**Re: Lot 18 DP 270644, Greystanes Southern Employment Land (Boral Land)
Section 96 Application SSD_6801**

We provide this letter relating to a proposed Section 96 application to the Greystanes Southern Quarry West project approved under SSD_6801. Specifically this letter covers the civil engineering aspects of the amendment.

SITE MASTERPLAN
SCALE 1:1500

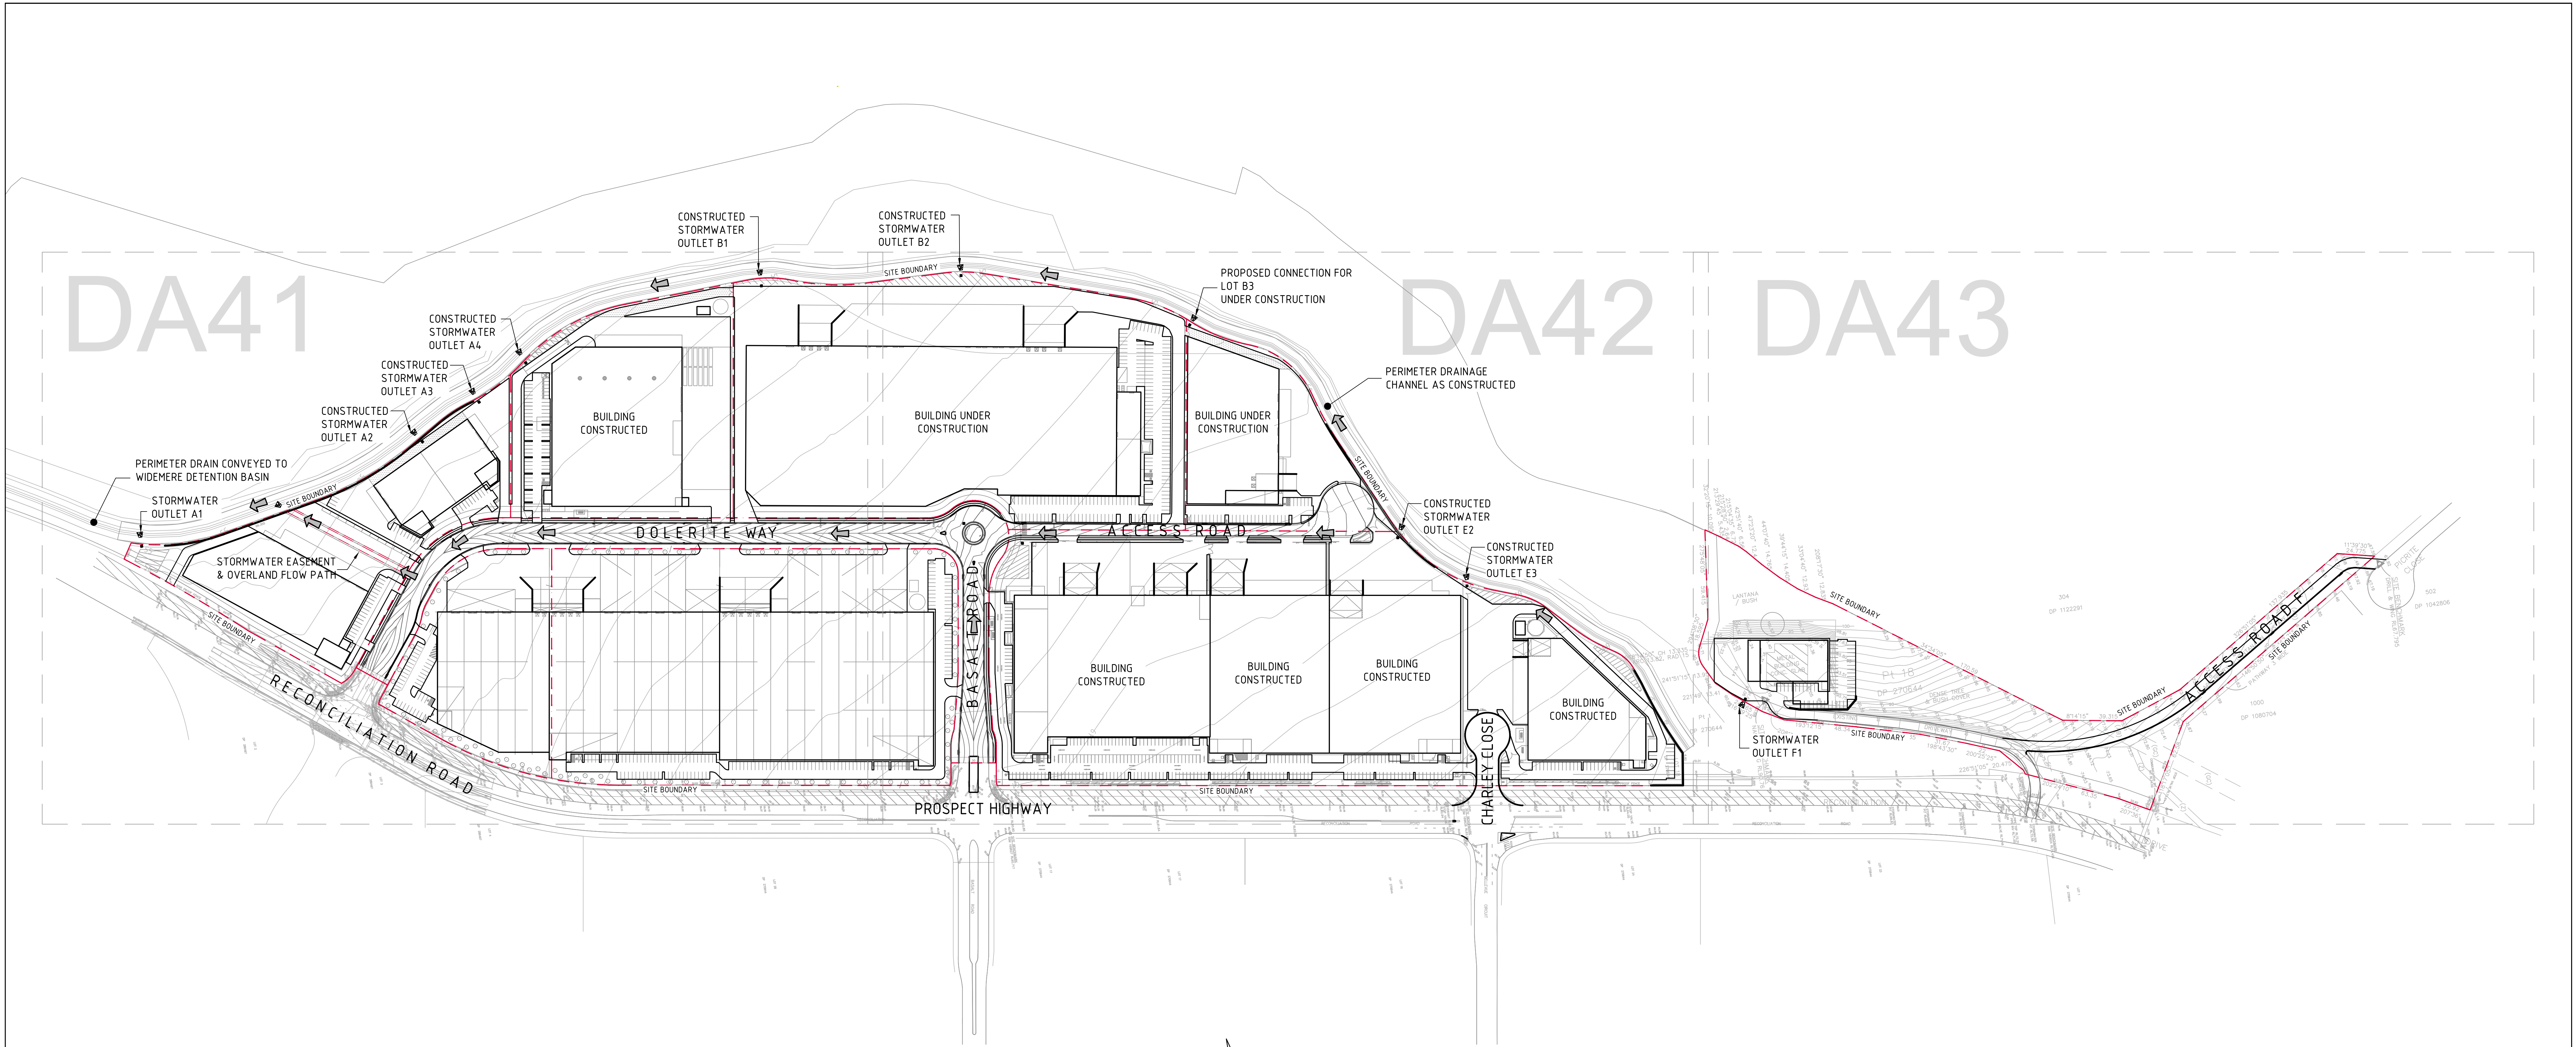
The development layout differs from the previous submission in that the arrangement of the development lots on the eastern side of Dolorite Close within Precincts C & D have been adjusted.

Adjustments to the masterplan relate to Warehouse C, Warehouse D1 and Warehouse D2. The lot layouts to the west and north of the estate road are generally consistent with the previous application. The building layout for Warehouse C has also changed. The floor

level Warehouse C, D1 & D2 have been amended to suit access from Dolerite Close, to meet flood planning requirements and to achieve cut to fill of earthworks over the site. It is noted that the final building level will be subject to detail geotechnical and earthwork volume assessment and may vary +/-500mm from the nominated level.

Minor adjustments to the locations of the bio-retentions within the site have been made. Basins within Precinct C have been adjusted to suit the proposed layout. Basin locations within Precinct D remain generally consistent with the previous application. It can be confirmed that the minimum required 3000m² of bio retention, as defined in SSD_6801, has been provided.
